PART MAIN FLOOR PLAN NO.2 - NEW WORK

PAN AM POOL - EAST VESTIBULES

ADDENDUM NO.2

RM-5

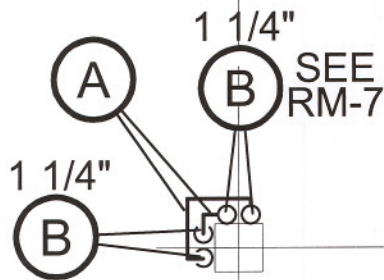
- A. Revised routing.
- B. Revised riser location.
- C. Existing drain, vent and domestic water to remain. Serves drinking fountain at Second Floor.
- D. Extend services to relocated drinking fountain.
- E. Existing drinking fountain shown relocated +/- 2'-0".
- F. See Architectural for new enclosure.
- G. Reconnect vent.
